WHEREAS, on October 25, 2010 by Roll Call No. 10-1728, the City Council duly resolved to consider a proposal from Quest Development to rezone certain property located in the vicinity of 320 Southwest 9th Street from C-3B Central Business District Mixed-Residential District to a PUD Planned Unit Development District classification, and to consider the proposed PUD Conceptual Plan for such property, and that such proposal be set down for hearing on November 8, 2010, at 5:00 P.M., in the Council Chambers at City Hall; and,

APPROVAL of a recommendation to find the request for PUD zoning for property located at 320 Southwest 9th Street in conformance with the Des Moines' 2020 Community Character Plan; and approval of the request to rezone the subject property from "C-3B" Central Business Mixed Use District to PUD Planned Unit Development and approval of the PUD Conceptual Plan subject to the following conditions: **ZON2010-00167**

1. **Purpose of Request:** The proposed development would allow construction of two separate four-story hotel complexes, including an extended stay hotel fronting Southwest 9th Street with 95 guestrooms and a standard hotel fronting Southwest 11th Street wit

N
SITE PLAN

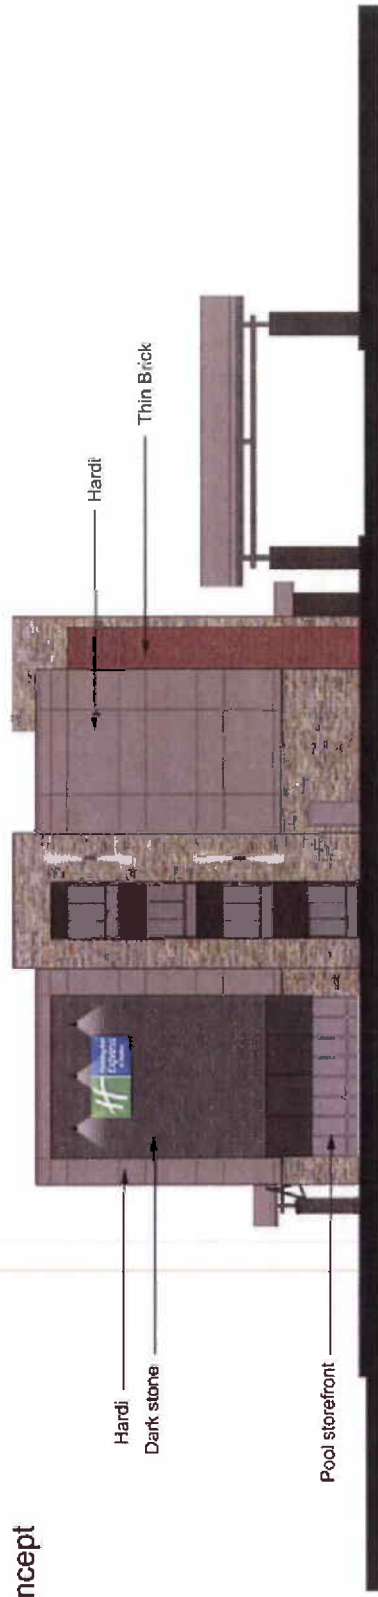
The submitted PUD Conceptual Plan includes building elevations for only 2 facades of each hotel. The PUD Conceptual Plan must include elevations of all four facades of each building. The proposed elevations indicate that each building would be 4 stories in height. The hotel fronting SW 11th Street would be constructed primarily with stone and brick materials, with hardi-siding and steel awning accents. The hotel fronting SW 9th Street would be constructed primarily with stone and brick materials, with hardi-siding and EIFS accents. Staff recommends that the elevations shall be required to incorporate all requirements of the City's Urban Design Review Board.

The PUD Conceptual Plan indicates that the site will be landscaped in accordance to the Landscape Standards as applicable to the "C-3B" District. Since the adopted Landscape Standards don't specifically mention "C-3B", staff recommends this note be revised to state the site shall be landscaped in accordance to the Landscape Standards as applicable to the "C-3" District.

The PUD Conceptual Plan provides a signage plan that includes a mix of wall-mounted and monument signs. The hotel along SW 11th Street would have a 2-square foot monument sign along both SW 11th Street and Tuttle Street and four wall-mounted signs. The hotel along SW 9th Street would have a 9.5-square foot monument sign along Tuttle Street and up to five wall-mounted signs. Staff recommends that any monument sign on the premises shall have a brick or stone base that matches the materials on the primary structure. The text at the left side of Sheet 4 that states signage will be in accordance with the "C-3B" requirements should be removed since it conflicts with the proposed sign diagrams on Sheet 4 and the proposed sign locations on Sheet 2, as "C-3B" regulations would only permit 100 square feet of wall-mounted signage per building.

SHEET 4 OF 4

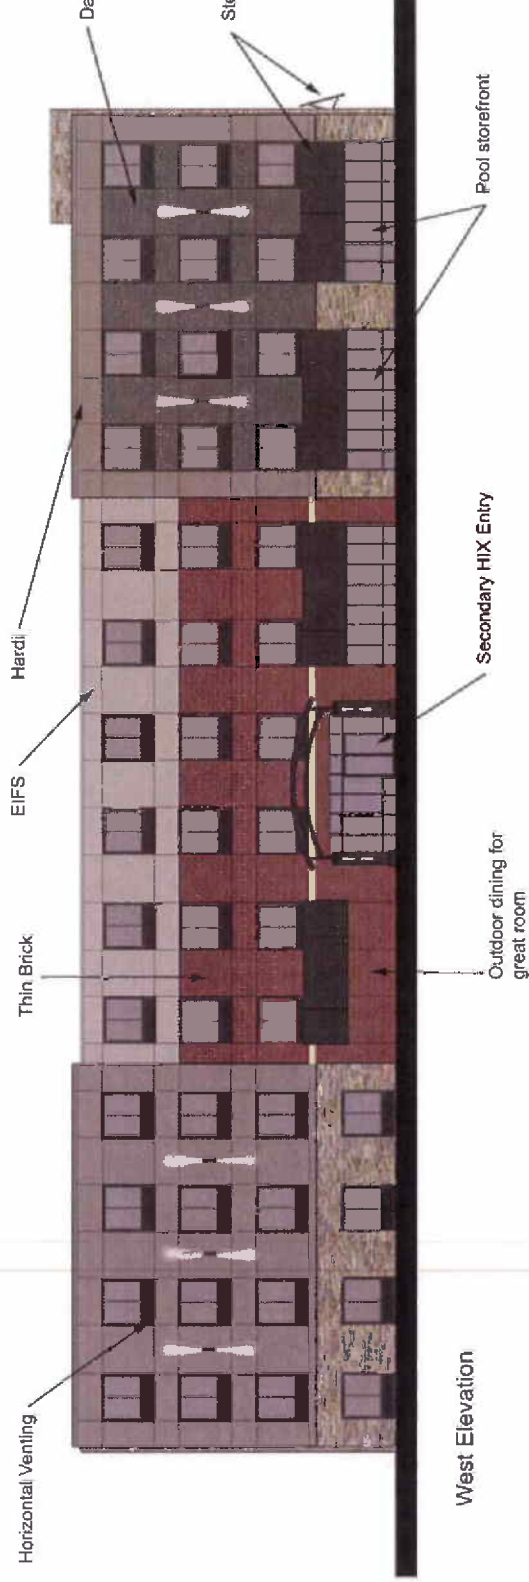
7. Any monument sign on the premises shall have a brick or stone base that matches the materials on the primary structure.
8. The text at the left side of Sheet 4 that states signage will be in accordance with the C-3B requirements shall be removed.

The monument sign on Sheet 4 as being located a ½-block north of the site along West Martin Luther King, Jr. Parkway cannot be approved as part of the PUD since it is not located on the premises.
